# T ECHNICAL INFORMATION

87942

- Subject** ▶ Addition of Front Spacer,  
Change of Under Driver Guide, M5x35 Hex Socket Head Bolt, Flat Washer 5, Hex. Wrench 4
- For Models** ▶ GN900
- Country** ▶ All countries
- Description** ▶ For further improvement in durability of Cylinder head;
  - 1) Front spacer has been added.
  - 2) Under driver guide, M5x35 Hex socket head bolt, Flat washer 5 and Hex. wrench 4 have been changed.

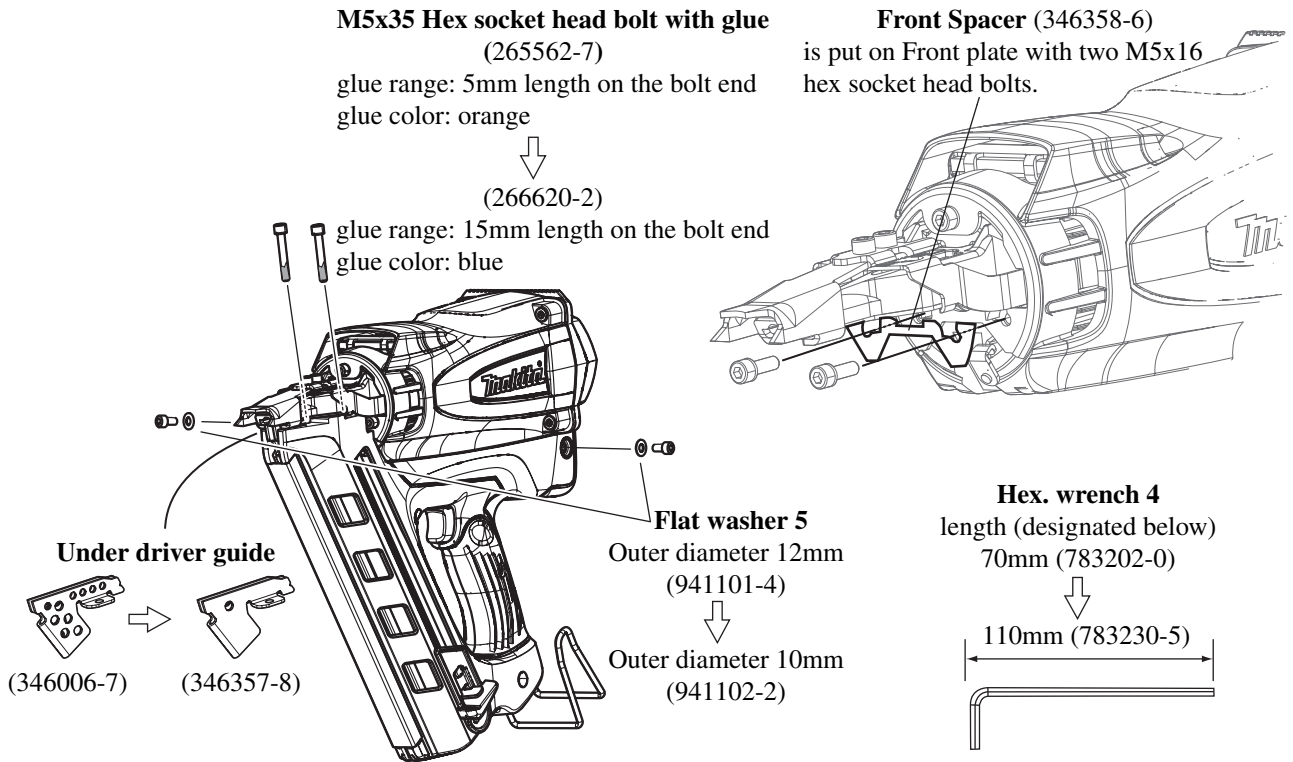
**Note:** In case of Cylinder head failure, all the following parts have to be replaced.

In case of Under driver guide failure, Under driver guide and two M5x35 Hex socket head bolts have to be replaced.
